Change to Product Bulletin Number 2 of 1995 10 March, 1995 (revised 9/97)

Subject: Locking Device for Yoke

Products Affected: Kirby Morgan SuperLite-17A/B & U.S. Navy MK-21 Mod. 0 & Mod. 1 Yoke/Neck Clamp. The Discontinued "As Standard" Locking Device

Older Push Pin

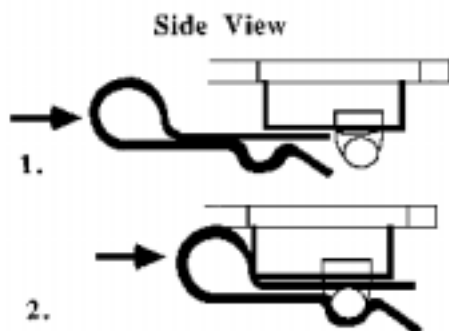
The yoke Locking device on the SuperLite-17A/B named the "Push Pin Latch Catch Assembly" Part Number 505-015 (brass) or 505-016 (chrome) has been the standard production configuration on all SuperLite-17 A/B & U.S. Navy MK-21 Mod. 0 & Mod. 1 Helmets in the United States prior to 1993. This Push Pin Latch Catch Assembly is now discontinued as the standard lock shipped with each SuperLite-17 A/B & U.S. Navy MK-21 Mod. 0 & Mod. 1 Helmets. No assemblies or replacement parts for this assembly are available.

KMDSI highly recommends that a Plunger Pin, our Part Number 540-080 be used to prevent the possibility of the yoke latching system on the SuperLite-17 A/B & U.S. Navy MK-21 Mod. 0 & Mod. 1 Helmets with the original style Push Pin Latch Catch Assembly Part Number 505-015 (brass) or 505-016 (chrome) from becoming disengaged by the unintentional depression of the plunger, or due to the Neck Clamp being bent or deformed.

This Plunger Pin, part number 540-080, is not a solution to an improperly working Neck Clamp. Be sure the Neck Clamp is not damaged and is working correctly.

The Updated Standard Pull Pin Latch Catch Assembly P/N 505-010 (brass) or 505-011 (chrome) for Kirby Morgan SuperLite-17A/B & U.S. Navy MK-21 Mod. 0 & Mod. I Yoke/Neck Clamp.

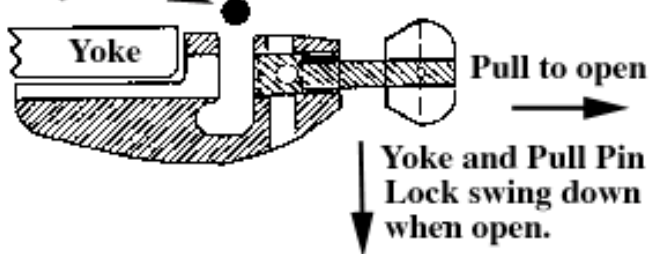
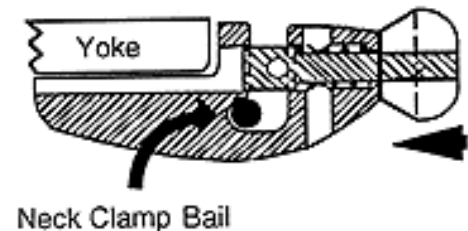
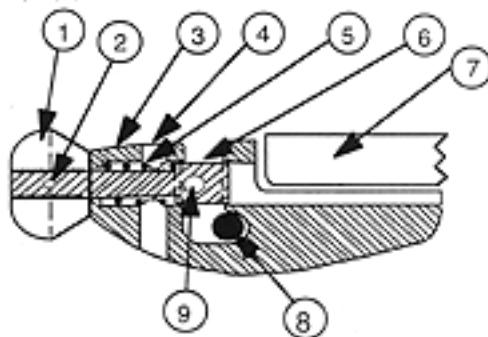
All SuperLite-17A/B & U.S. Navy MK-21 Mod. 0 & Mod. I Helmets sold by KMDSI now have the Pull Pin Latch Catch Assembly", Part Number 505 - 010 (brass) or 505-011 (chrome) on the helmet to lock the Yoke in position. The mounting system for the Pull Pin Latch Catch Assembly is identical to the old style.

Each Pull Pin Latch Catch Assembly is shipped with a Safety Pin, Part Number 535-900 which we recommend be used when the user requires a two step release system on the helmet. It can be used with or without a cord attached to prevent loss of the Safety Pin when not in use. All Pull Pin Latch Catch Assemblies, P/N 505-010 or 505-011, which are sold as spare or replacement parts include this Safety Pin, P/N 535-900.
